**TOWN OF GLASTONBURY
BID NO. GL-2020-07**

MAIN STREET RAISED TRAFFIC ISLAND

**ADDENDUM NO. 1
SEPTEMBER 16, 2019**

PLAN
DEPICTING PROPOSED
TRAFFIC ISLAND IMPROVEMENTS
located at
MAIN STREET & HEBRON AVENUE
GLASTONBURY, CONNECTICUT

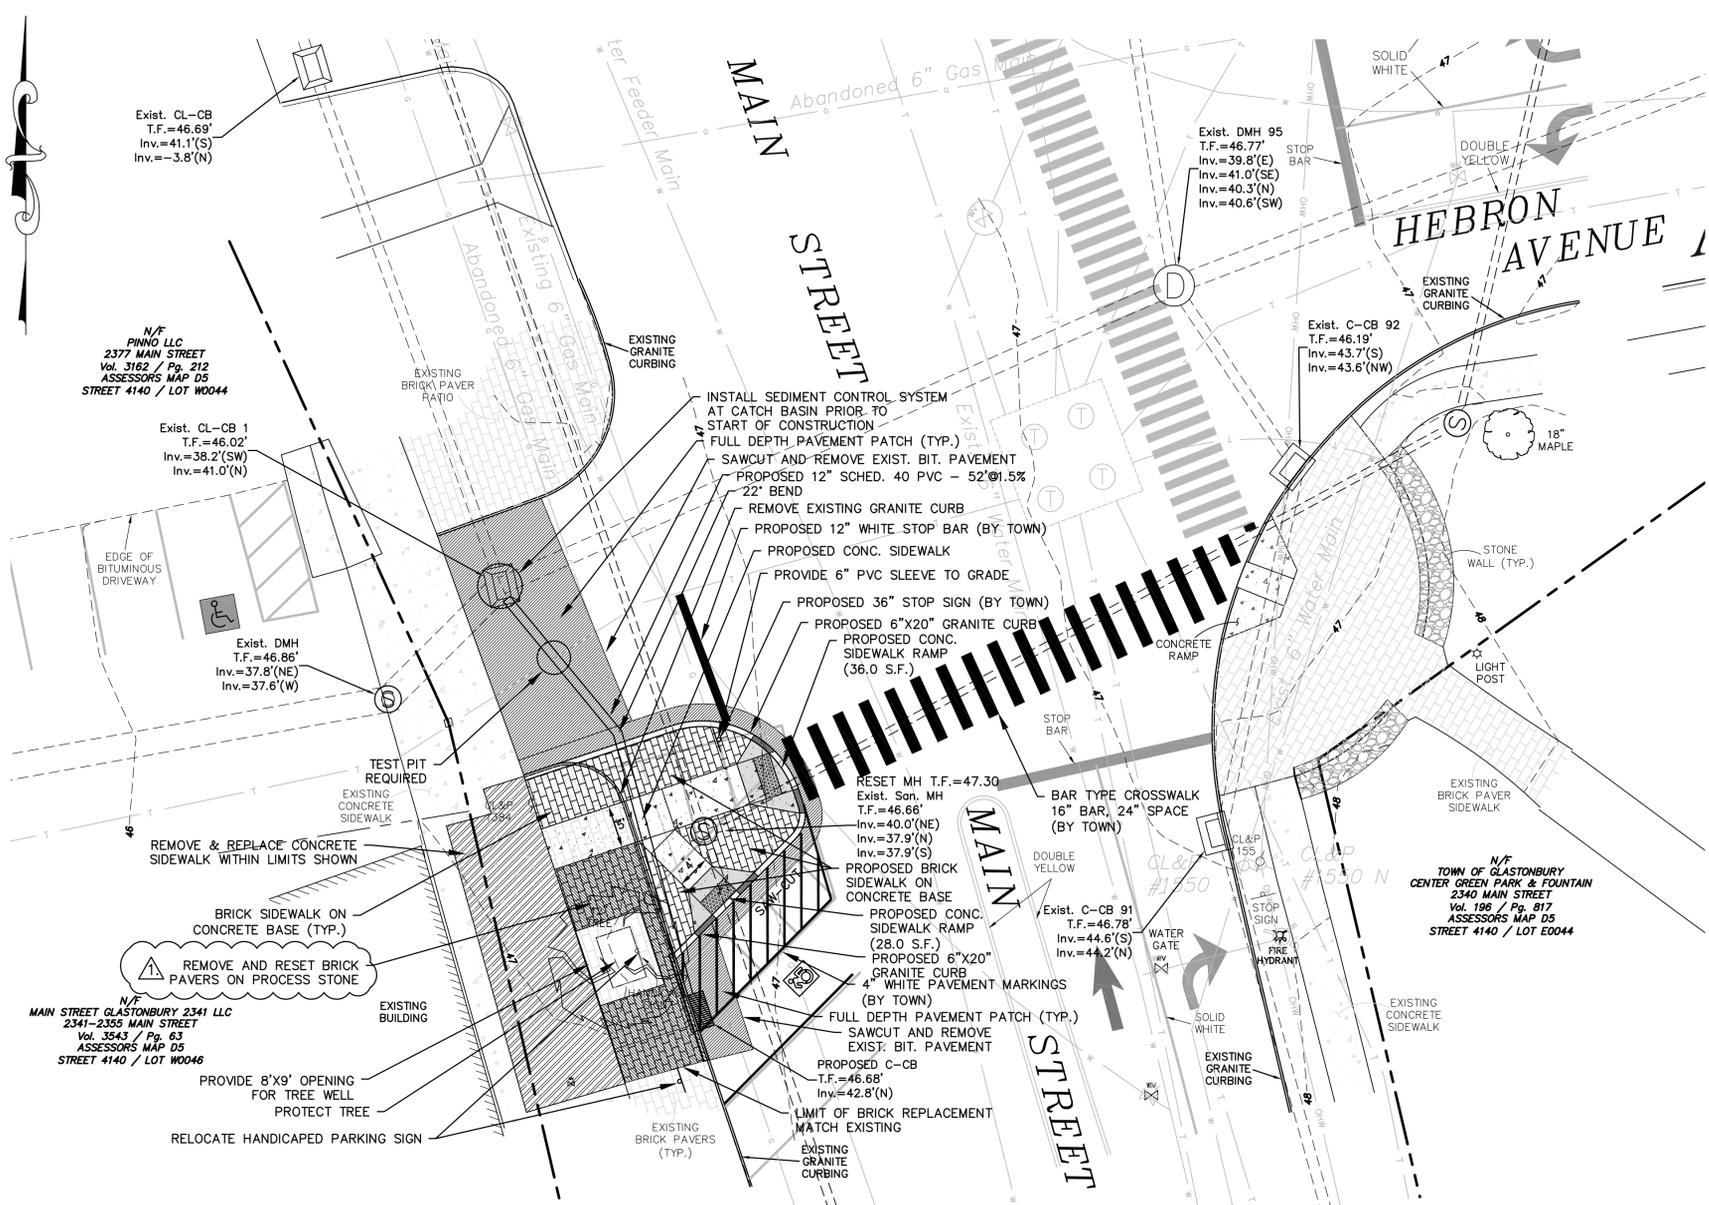
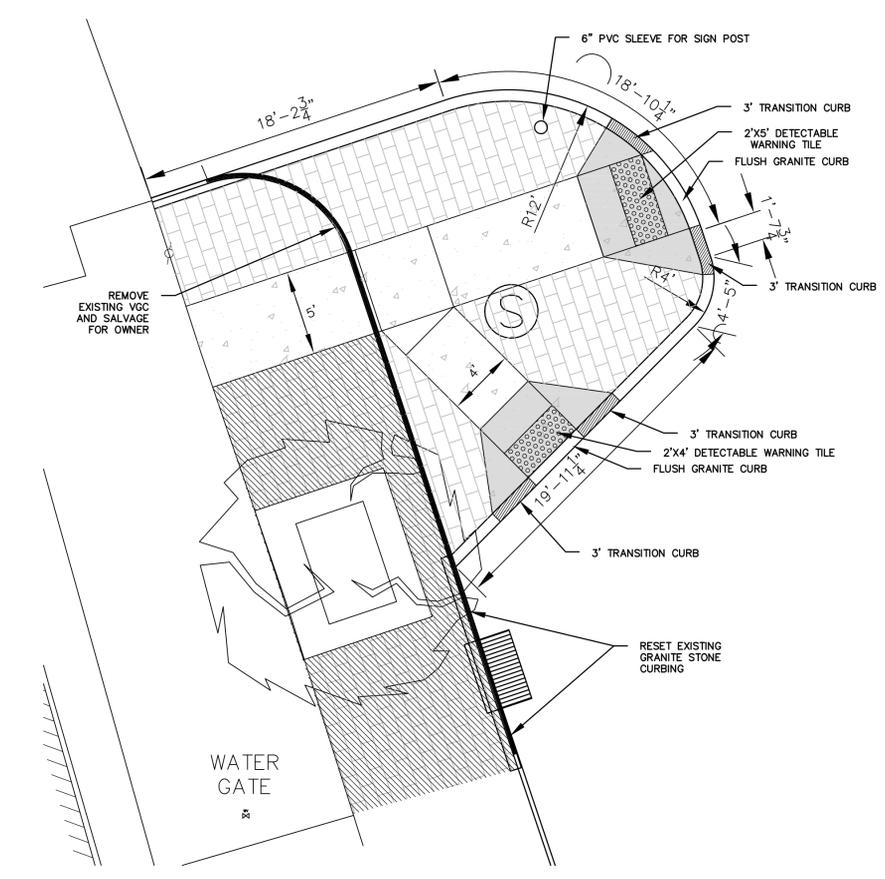
Sheets 1 of the plan set titled "PLAN DEPICTING PROPOSED TRAFFIC ISLAND IMPROVEMENTS LOCATED AND MAIN STREET AND HEBRON AVENUE, GLASTONBURY CONNECTICUT" is hereby replaced with the attached plan. Changes shown on Sheet 1 include notes depicting removal and resetting of existing brick pavers in the vicinity of the existing town-owned locus tree which is to be completed as described in the special provision listed below.

DRAWING ISSUE STATUS		
NO.	DESCRIPTION	DATE
1	ADDENDUM 1 RESET BRICK PAVERS AROUND TREE	9/16/2019
